Docket Item # 3  
BAR CASE # 2007-0136

BAR Meeting  
October 24, 2007

**ISSUE:** Addition and Alterations

**LOCATION:** 419 North West Street

Figure 1: Proposed east elevation

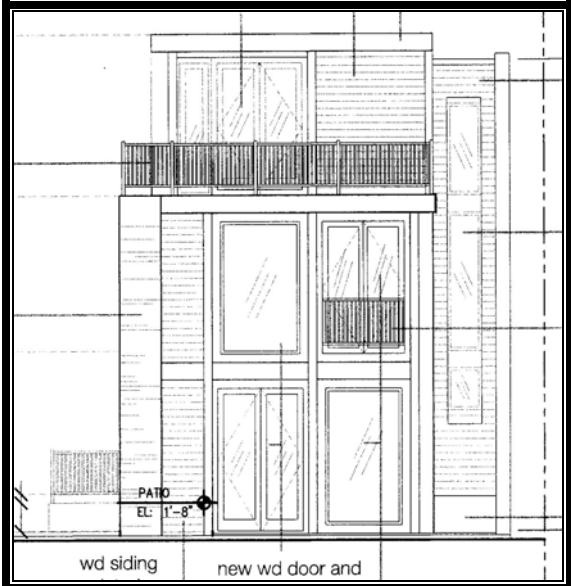
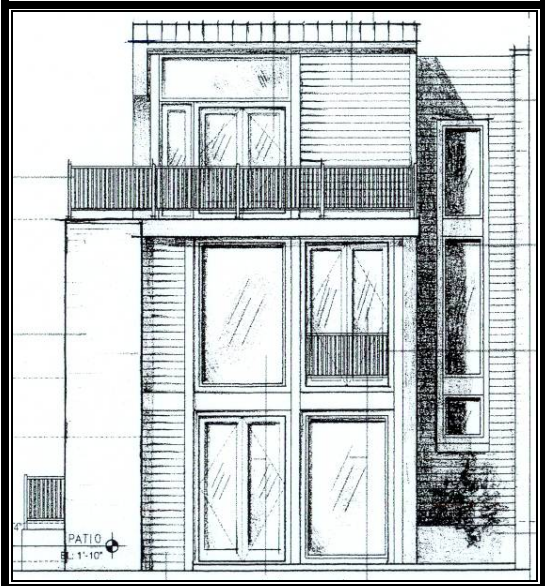
The east (rear) elevation will also be composed of three major blocks. Two of these will be narrower than in the previous design: the two story block, reduced in width by 2' will now be no wider than the existing house and the stair tower will also be 2' narrower. In the forefront will be the two story block and, set back 4' above this, the third story. The three story stair tower on the north side will be in the background, set back 21' from the face of the two story block. The two story block will have a brick pier at the left side where it wraps around from the south side. Beyond this, it will have a narrow strip of wood siding and then a large expanse of glazing. There will be French doors and a large full length window on the first story. The second story will have the same, only the positions of the door and window will be the reverse of those below. The second story door will have a wood railing at the base. The two story block will support a deck for the third story that will be surrounded by a wood railing. The third story east elevation will have a French door with a sidelight on the left side. Previously this entrance also had a transom. The right side will be clad in wood siding. The east elevation of the stair tower will match that of the west elevation with a long narrow window divided into three sections separated by wood panels within a wall clad in wood siding. There will be a brick planter at the base of the stair tower.

Figure 3: Proposed west elevation

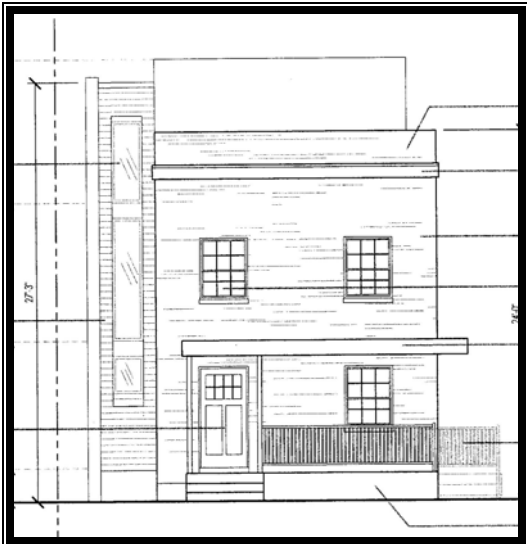
The addition will project above the existing house by a story and beyond the existing house on both the north by 4'6". The third story will project approximately 4'9" above the main block of the house which will have added height with the new brick parapet. The west elevation of this portion of the third story addition will have no openings. It is not clear from the drawing what it will be clad in. On the north will be the stair tower. The narrow end of this three story rectangular block faces the west. It will be clad in wood siding and will have a long narrow window divided into three sections separated by wood panels. On the south side, the addition has been pulled in even with the existing house and thus will not be as visible. The overhang, trellis and entrance steps to the addition will be visible on the south side.

Figure 5: Proposed south elevation

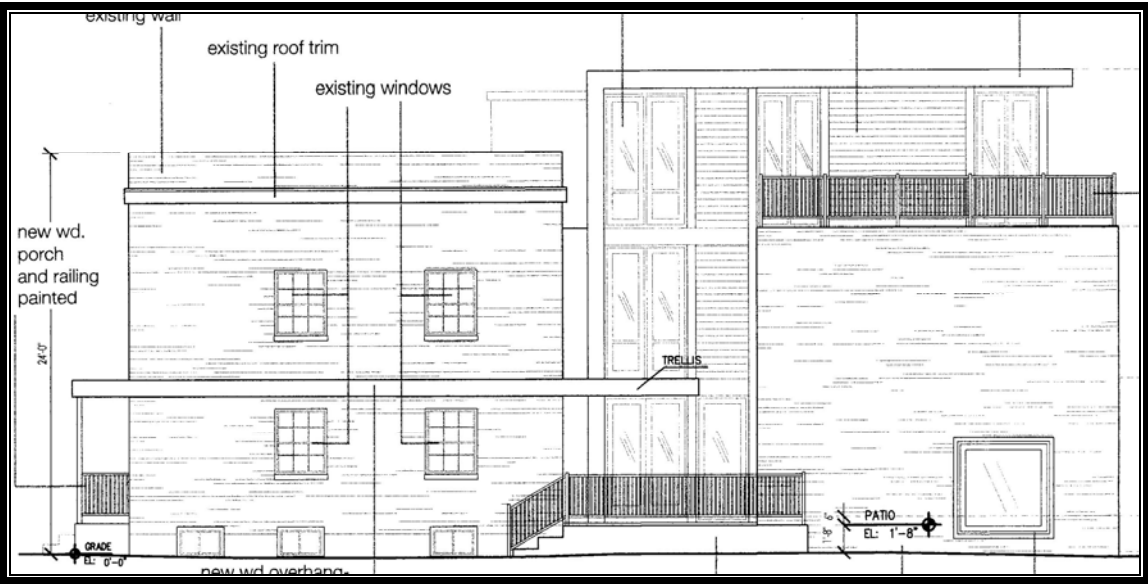
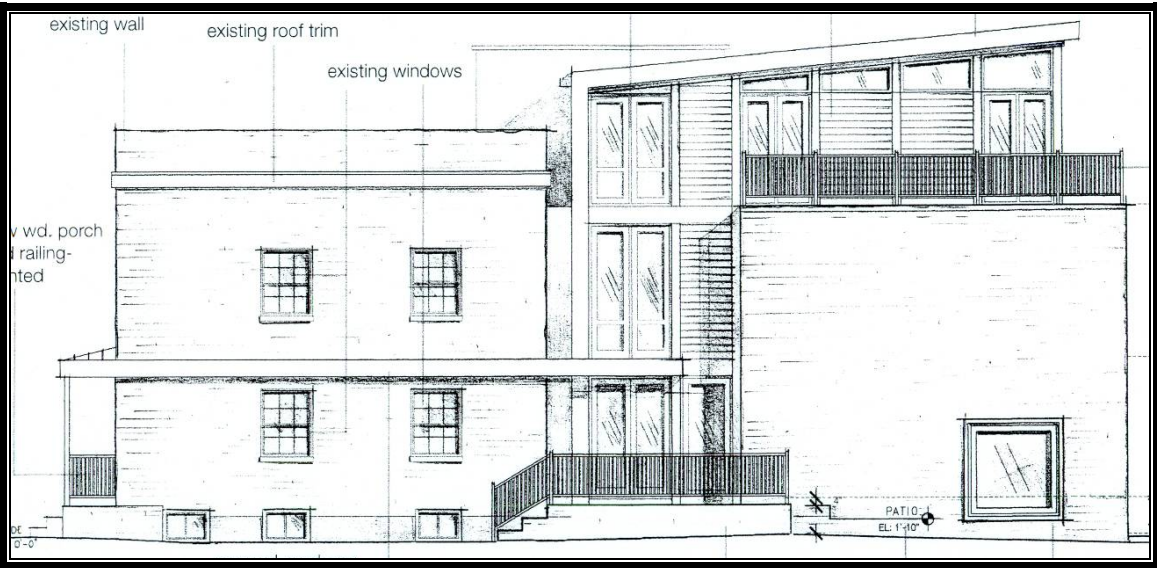
The addition will be composed of three major blocks on the south side. In the forefront and toward the rear or east will be a two story brick block having a single, 6' by 6' square window in the first story at the east end. In the current design, this block is even with the plane of the existing house. Previously it projected beyond it by 2'. This brick block will support a deck at the third story level that will be surrounded by a wood railing. Set in behind the brick block will be the plane of the three story block. This section had a sloping roof rising to 30' at the back. The roof is now flat and a consistent 28'9". This section will be clad in wood siding and will have vertical trim strips defining the bays and horizontal strips defining the stories. A new entrance to the house will be located on the south side, accessed by a new brick terrace with wood railing and trellis over the entrance area. The door will be a French door with glazing above and wood panels below. A full length window will be located to the right of the French doors, functioning as a sidelight. Paired long windows with wood panels below will be located in the second and third stories directly above the entrance. There will be two additional window groupings of this same design on the third story, overlooking the deck. The stair tower, located on the north side, will be visible above the existing main block and the new three story block. It will have a flat roof, no openings and will be clad in wood siding.

Figure 7: Proposed north elevation

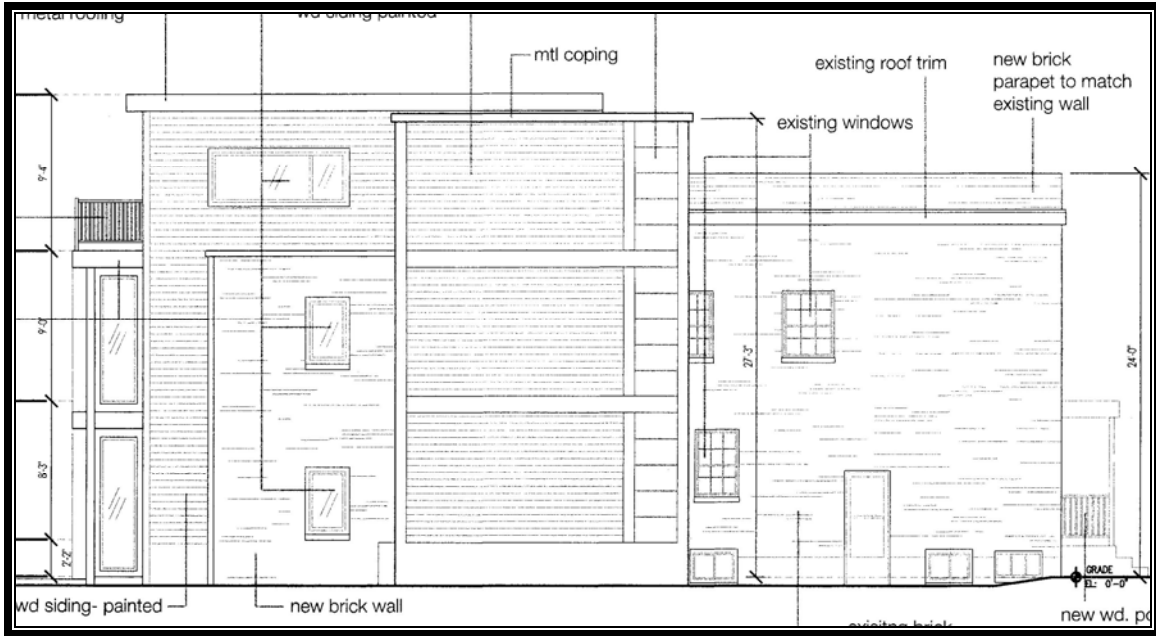
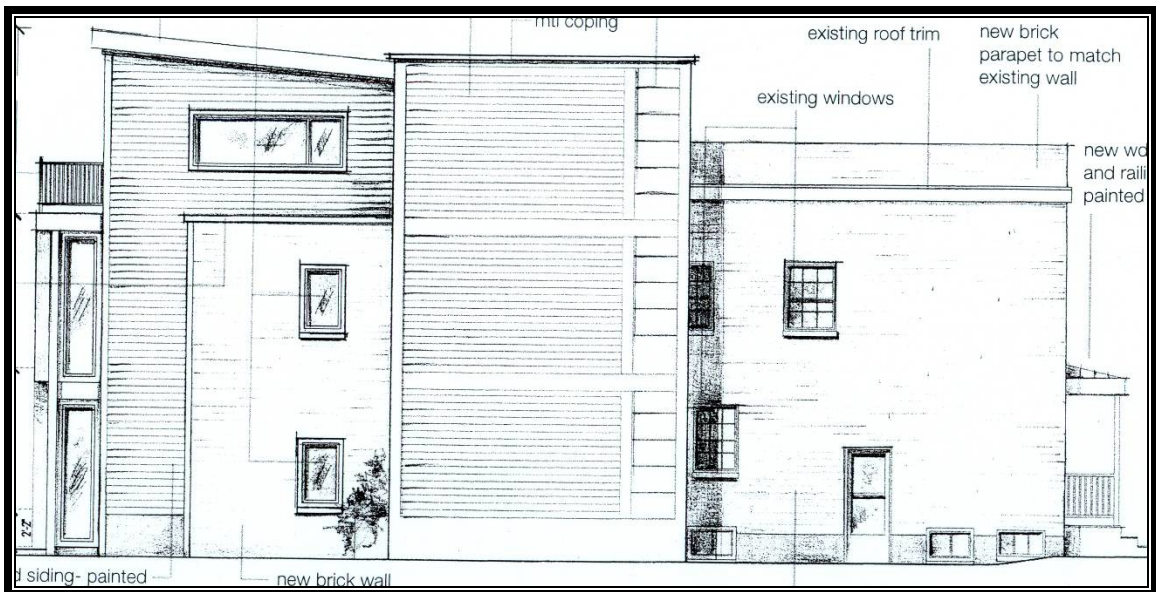
Again, the north elevation is composed of three major blocks; the three story stair tower at the forefront, the three story portion of the addition set back 6'6", and the narrow sliver of two story addition at the east end. The 17'7" wide north wall of the stair tower section will be without openings. It will be clad in wood siding with a narrow strip of wood panels at the west end. Horizontal wood trim strips will define the three stories. Beyond this will be the three story addition which is broken into two fields, one clad in brick and one in siding. There will be a window in each story. A rectangular window will be located in the first and the second story near the west end of this section. A long horizontally oriented window will be located in the third story, more or less centered in the section. On the same plane with the three story section is a narrow two story section that is almost entirely glazed, consisting of a full length window in the first and second stories and supporting the third story deck with wood railing. The only modification in this elevation is the change in the roof over the three story section from sloped to flat.
